## RECALL INSPECTION BULLETIN

GENESIS HYBRID FRAMELESS DUMP TRAILER

SUBJECT: Inspecting Draft Arms Regarding Safety Recall 17V-684 DATE: February 2018 REV: C

View of crack from inside face of the draft arm tubing

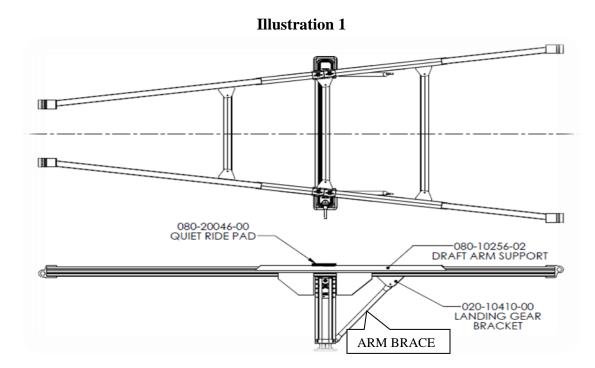
Under a combination of events, it is possible for a crack to start forming at the landing gear brace bracket. If not corrected, the crack can spread until a failure of the draft arm assembly can occur.

East Manufacturing Corporation will voluntarily remedy this defect at no charge to the trailer owner via a modification to the draft arm assembly. If a crack has already formed, the draft arm assembly will need to be replaced at a *repair facility previously trained by East Mfg. on hybrid repairs*.

If cracks are found to have started, the owner of the trailer will need to go to an East Mfg. Dealer, *previously factory-trained on hybrid repairs*, to have a new draft arm assembly installed.

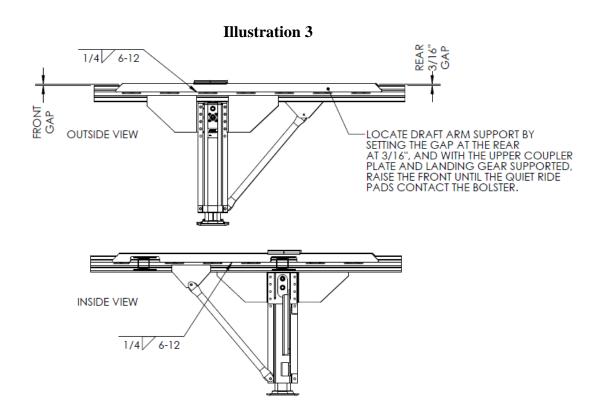
- 1. Unbolt landing gear arm brace from landing gear bracket. See Illustration 1
- 2. Cut existing landing gear bracket off, no closer than 3/8", from the bottom of draft arm tube and discard. *Do not cut, sand or grind the existing welds on the bottom of the draft arm tube.*

- 3. Bolt the new landing gear bracket (PN 020-10410-00) to the landing gear arm brace, then rotate upwards until the bracket overlaps the inside face of the draft arm tube by 2". Bracket may need to be trimmed down to avoid interfering with the crossmember currently in place.
- 4. Weld only the top of the bracket to the tube starting and stopping ½" from the vertical edges. See weld pattern in Illustration 2

- 5. Cut the existing welds on the draft arm support, remove and discard the support. See Illustration 1
- 6. Sand and clean the sides of the draft arm tube to prepare for welding.

- 7. Position new draft arm support (PN 080-10256-01 and 080-10256-02) on top of draft arm tube with the notches facing the center of the trailer and the notches straddling the center and rear crossmembers. See Illustration 1

- 8. Position 2 quiet ride pads (PN 080-20046-00) on top of each draft arm support, centered underneath the bolster. Weld in place. See Illustration 1
- 9. Shim the rear of the draft arm support by 3/16". With the upper coupler plate fully supported against the saddles and the landing gear supported, raise the front of the draft arm support until the quiet ride pads contact the bolster.

# **Illustration 4**

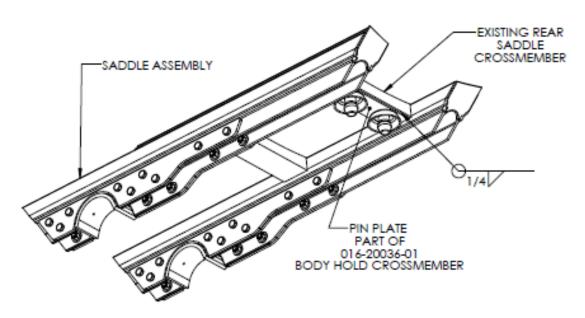
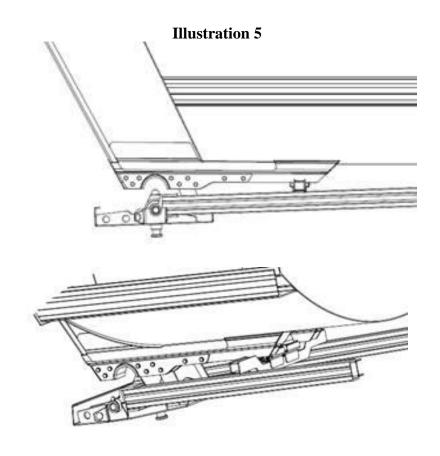
- 12. Locate rear saddle crossmember on body. See Illustration 4
- 13. Center crossmember assembly (PN 016-20036-01) under rear saddle crossmember. Weld the hold down pin plate (PN 016-10171-01) in place. See Illustration 4 for weld pattern

## **Illustration 6**

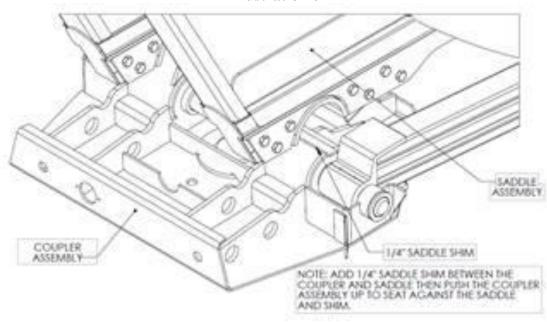
- 15. Mark and trim hold down crossmember assembly to fit inside the draft arm width. See Illustration 5
- 16. Using the included shims (PN 016-10179-00), space the upper coupler plate ½" from the saddles. Make sure the upper coupler plate is supported and tight against the shims and saddles. See Illustration 6

## **Illustration 7**

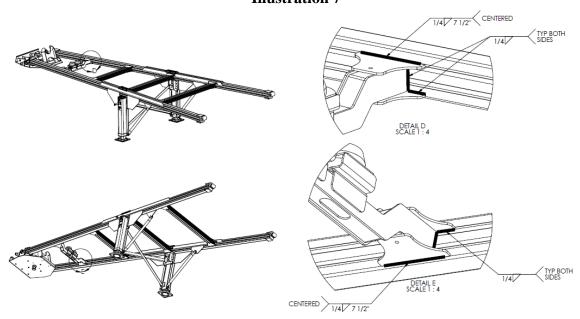
- 17. Weld the hold down crossmember assembly to the draft arms on the vertical faces, place and weld the gussets (PN 016-10174-00) on the top and bottom. *Stop welds ½" from end of gussets*. See weld pattern on Illustration 7
